Reference: 15S1176000

RE: PALING YARDS WIND FARM – RESPONSE TO TRAFFIC RELATED SUBMISSIONS

Responses to Transport Related Comments

Figure 1: OD Transport Route between Port Kembla and Paling Yards

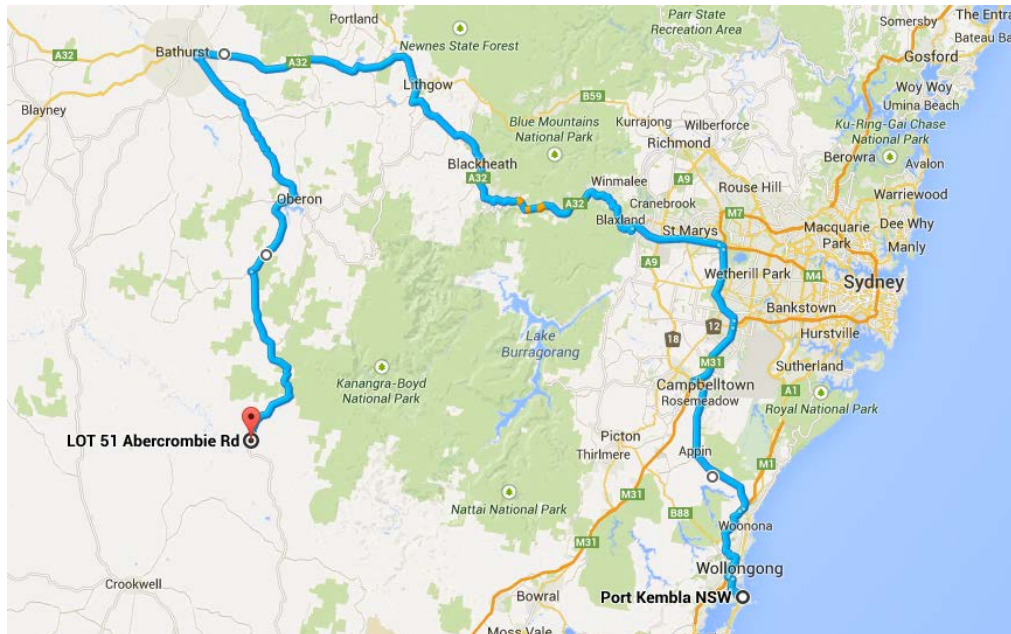
The EIS indicated that Bells Line of Road would be used as the proposed OD Transport Route across the Great Dividing Range. Following consultation with the RMS Special Permits, team it has been confirmed that this route is not supported. As such, the proposed use of the Great Western Highway (Route A32) has been investigated further.

EIS Submission from (ID)	EIS Submission Comments	Response
RMS (100347)	The selected road transportation routes for materials from Port Kembla and Port of Newcastle to the site assumes access from Sydney using Bells Line of Road (MR 184) and possibly Great Western Highway (HW5). Access across the Great Dividing Range for over size/over mass and some low loader vehicles is not possible using Bells Line of Road and may not be possible using Great Western Highway. Transportation access from east to west by road will need to be obtained, subject to approval, via roads other than Bells Line of Road. In developing new routes, the proponent is strongly encouraged to consult with Roads and Maritime Special Permits Unit on 1300 656 371.	RMS Special Permits branch has been consulted and an assessment of the proposed over-dimensional transport route via Great Western Highway (A32) is provided in the additional assessment undertaken by GTA Consultants. The use of Great Western Highway is feasible, however a number of potential conflicts have been identified. A detailed Traffic Management Plan and scope of any road modification works would be developed in consultation with RMS and respective Council prior to any over-dimensional wind turbine component movements.

The proposed access route from the M7 Motorway is shown in Figure 1 and described as follows:

- M7 Motorway
- Turn onto the M4 Western Motorway (westbound) at Light Horse Interchange
- Continue onto the Great Western Motorway (A32) for 145 kilometres
- Turn left into Littlebourne Street (O'Connell Road) at Kelso
- Turn Right into Abercrombie Road at Oberon
- Continue for approximately 70 kilometres to the proposed development site.

The proposed route from Port Kembla to the development site can be undertaken in approximately 5 hours by car. It is however noted that it could take up to 15 hours (based in an average speed of 25km/h) for the proposed oversize transport vehicles. Given the weather conditions that are apparent in the Blue Mountains during the winter months (ice/ snow), an assessment of the appropriate timing of vehicle movements should be undertaken in the Traffic Management Plan to be prepared for the works.

Figure 5: Access 2 (looking south)

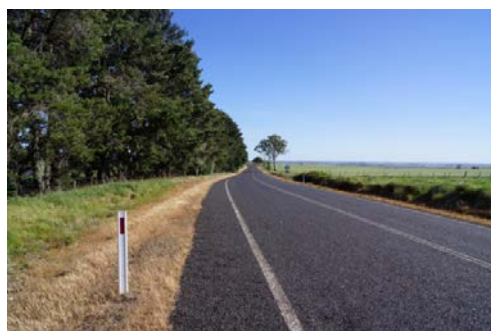
Oberon Council (100345)	The EIS specifies there will be six access points from Abercrombie Rd into the development site; however the descriptions of the locations are not sufficient to accurately determine them on site. It is requested that they be marked on site to enable sight distances to be checked. Further information is also requested as to whether all six will remain as permanent accesses, or will they be in place only during the construction phase. If they are only temporary, sight distance is not considered to be as critical. However traffic control may be required when they are in use.	Additional details of the access locations have been provided within the assessment undertaken by GTA Consultants, with detailed designs required to demonstrate appropriate sight distances. This includes the coordinates and photos of each access location. All access locations are to remain accessible post construction to allow for maintenance and inspection of the turbines.

Oberon Council (100345)	Accurate identification of the access locations is also important to determine if any significant vegetation will need to be cleared and to enable Council to set any conditions on their design.	Additional details of the access locations have been provided within the assessment undertaken by GTA Consultants. This includes the coordinates and photos for each access location.
Oberon Council (100345)	The EIS states that in two locations the new accesses will form a "crossroads" on Abercrombie Rd (accesses are opposite each other). This is not desirable, but can be avoided with just a small offset between the two accesses.	Access 4 and Access 5 would be constructed as staggered T-intersections to improve safety at these locations; details of which will be determined during detailed design.

Access 2 would form a T-intersection with Abercrombie Road approximately 4.5km north of the Abercrombie River crossing. The exact location would be finalised at the detailed design stage, however it is anticipated to be at approximately 34°09'49"S and 149°44'49"E. The eastern side of Abercrombie Road in the vicinity of Access 2 has mature non-native pine trees which would require clearing for the proposed intersection unless it is constructed further north into grassland. Upon visual inspection, it is anticipated that the SISD for the proposed intersection would be achievable. However, the presence of a steep horizontal curve followed by a gradual dip in the road to the north should be considered during detailed design. Figure 4 and Figure 5 show Abercrombie Road in the vicinity of Access 2.
